<b>Issue Severity:</b>	<b>Products Affected:</b>
<input type="checkbox"/> <b>High:</b> Act immediately	<ul style="list-style-type: none"><li>• F01U100387, API-AEC21-4WR</li><li>• F01U100388, API-AEC21-8I8O</li><li>• F01U126751, API-AEC21-4WRZ (P.R. China only)</li><li>• AEC 2.1 systems running extension boards</li></ul>
<input checked="" type="checkbox"/> <b>Medium:</b> Recommended action(s) described below	
<input type="checkbox"/> <b>Low:</b> Advisory

### 1.0 Issue

### 3.0 Immediate Resolution

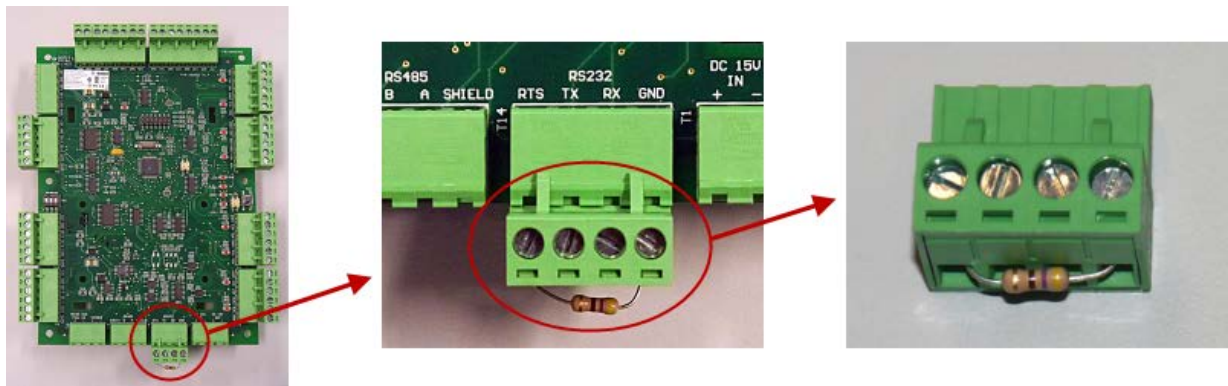
AEC 2.1 systems may exhibit the following symptoms when two or more extension boards are connected:

- AEC panel produces a continuous beeping sound that indicates a loss of communication between the CPU and extension boards.
- The AEC system is unable to detect some extension boards.

- Customers will fix the 470 ohm resistors to the termination point T14 on the extension boards of AEC2.1 4 Wiegand Reader Board and/or AEC2.1 8 Input-Output Board. The resistors are terminated at the end points (RTS and GND) of the four-way connector.
- The included reader board in the APC-AEC21-UPS1 kit will not require a 470 ohm resistor. All other extension boards (2-16) connecting to the supplied reader board in the UPS1 kit will require this resistor if experiencing the symptoms outlined in section 1.0 Issue and validated by technical support.

- Perform a system reboot to restore AEC 2.1 communication between the CPU and extension boards.
